## BRODIE OAKS REDEVELOPMENT GRADING PLAN

## Exhibit L

### COMMENT REPORT

PROJECT NAME: Brodie Oaks Redevelopment

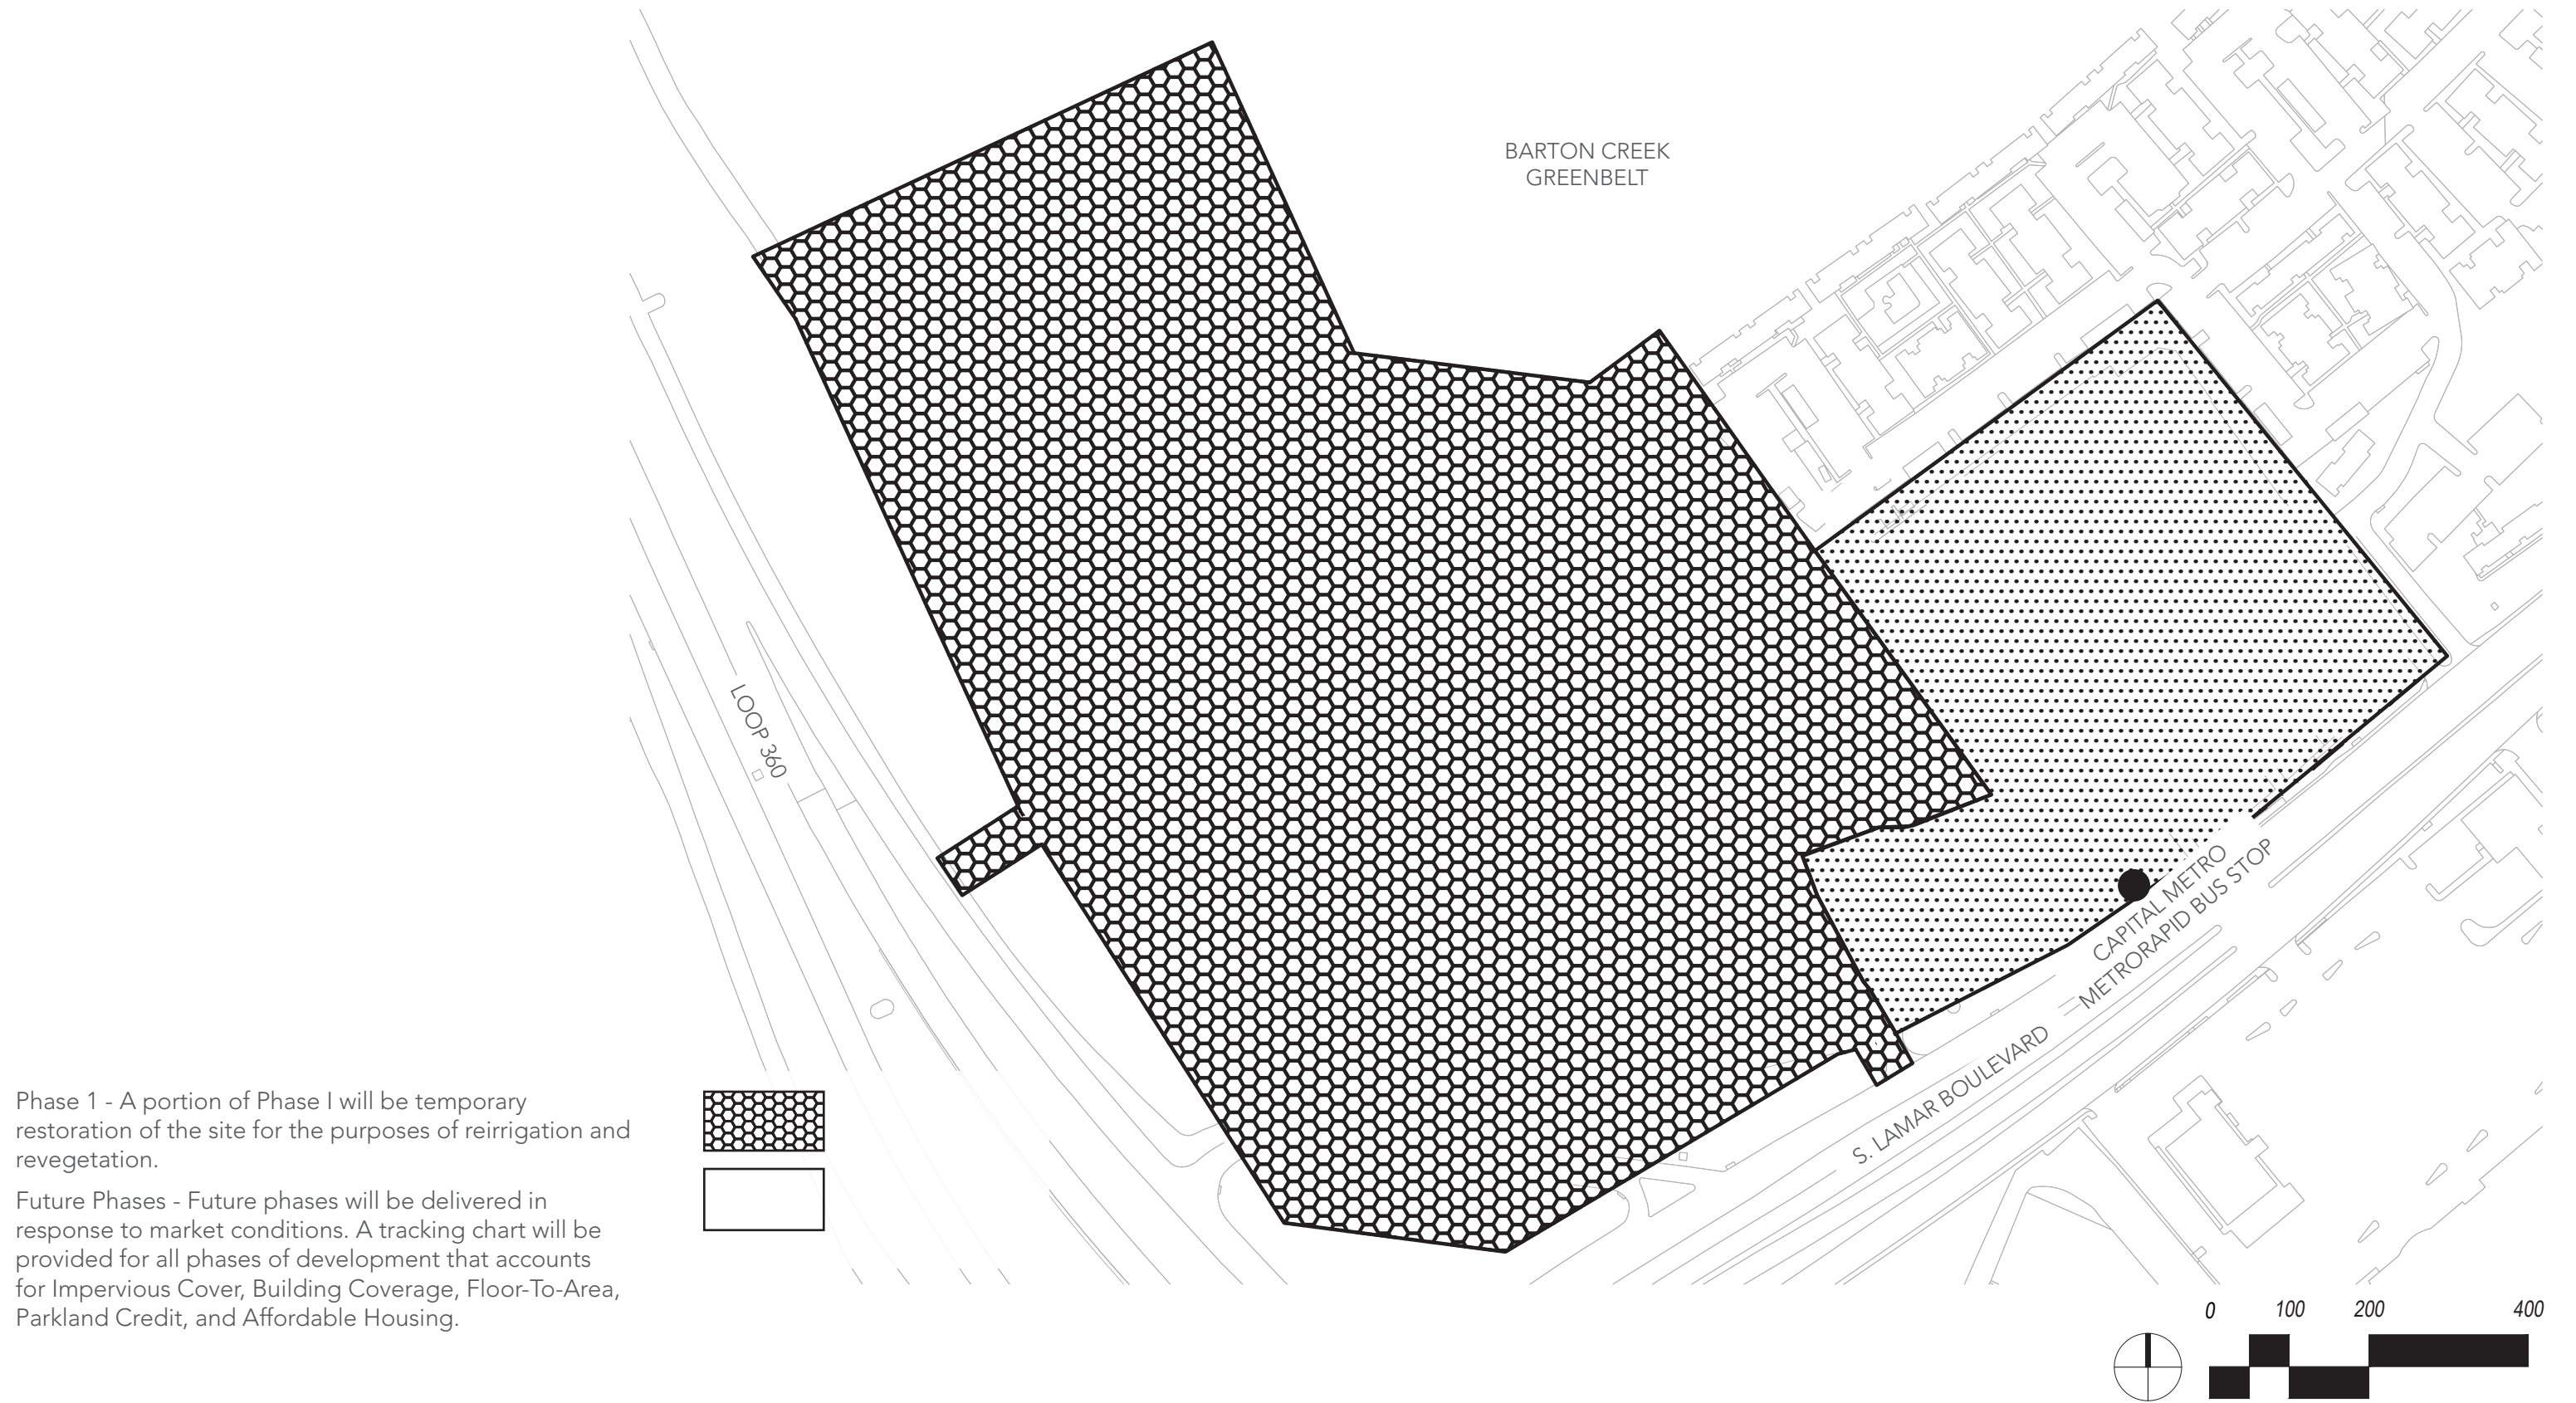
- CA 9. Exhibit G – Grading. For those areas of cut and fill proposed greater than four feet, please provide additional information and clarification on the overall disturbance of these requests and the trees potentially impacted in these areas. This request goes toward reviewing the PUD's overall tree preservation effort.
- CA 10. Trees proposed to be preserved must be shown with a continuous circle.

- EV18. Exhibit G: In alignment with comments EV 10 and EV 11, provide callouts or show more detailed information on the plan in order for Staff to fully determine if the proposed grading exceeding four feet in depth meets compliance with current code requirements and exceptions.

Parks must be designed to properly function as parks. Currently, the Trailhead Park appears to consist mostly of ponds in the Grading Plan. Please revise the Grading Plan so that there is more evenly-graded, unencumbered parkland, or show in the park development plan how the parks will function given the constraints of the ponds. Likewise, the grading of the Overlook Park has cuts of over 12 feet. Is this also for drainage? Parks must be evenly-graded in order to meet parkland dedication standards.

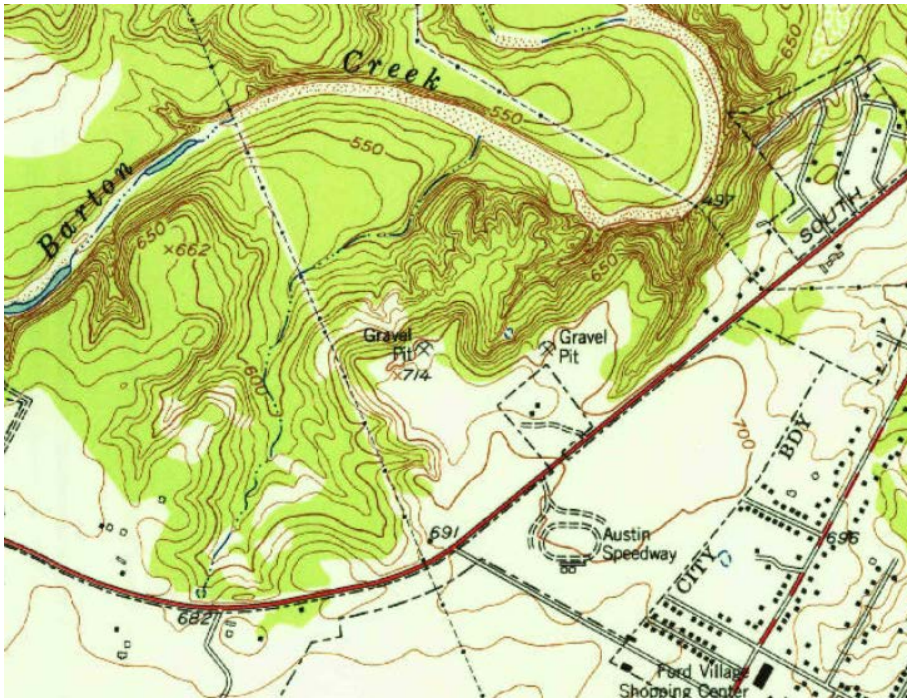
- EV12. 25-8-341/25-8-342: In addition to comments EV 10 and EV 11, according to aerial imagery as far back as 1955 (see below), the site was a gravel pit for several decades prior to the existing development. Historically, it has been the interpretation of Staff that grading in excess of four feet to restore pre-development grades is an acceptable exemption to City Code 25-8-341/342. Remove this proposed code modification from the proposed PUD application.

Figure 1. 1972 – cave passage survey

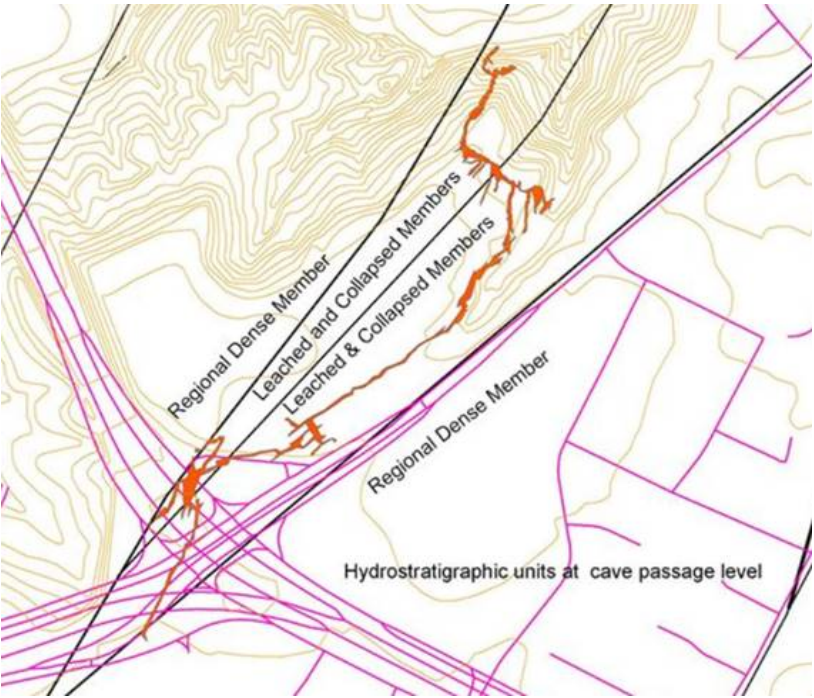
- HG 1. At this time, site specific information is unavailable or inaccurate regarding vegetation, areas of steep slope, or other environmental features such as bluffs, springs, canyon rimrock, caves, sinkholes, and wetlands. For example, the Environmental Resource Inventory Report prepared does not identify Airmans Cave, which is a cave listed on the City of Austin's 10A Permit. The cave passage is located beneath the site and is within 150-ft. The approximate location of cave passage is shown in map view below (Figure 1). Please be advised that according to Nico Hauwert, the 1972 survey map shown in red was not done with inclination measurements, so the actual horizontal distances are shorter than shown on the map, and one cannot determine rise in the cave passage from the entrance from the 1972 map. In 1995/1996, Mark Sanders, Jim Kennedy and Nico Hauwert remapped 2/3 of the Cave. The profile attached shows the cave depth relative to the surface for the first 2/3 of the cave were surveyed (Figure 2). The attached map compares their survey (green dots) to the red scan of the 1972 cave map (Figure 3). Please update the ERI report

to include Airmans Cave and any protective measures proposed to preserve the cave itself and the water quality and water quality in the cave.
